Re: Report of Threshold Inspection Activities - May 29, 2023 to July 16, 2023
Towneplace Suites Hotel - Northwest Commerce Parkway
Columbia County Permit No. 000046333
Lake City, Florida
AGES Job No. J20910; Report No. 004

AGES of JAX, Inc. (AGES) is pleased to present its third report of threshold inspection and construction observations made during the period of May 29, 2023 to July 16, 2023.

Deficiency Item No. 1
10 of 1

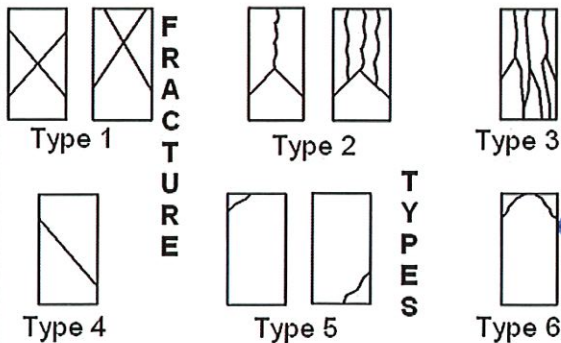
LOCATION OF POUR: Slab on Grade - Column Line 17 on Column Line K

REMARKS: At 28 Days, Average Compressive Strength Does Not meet Project specifications. Hold Cylinder will be Tested at 56 days.
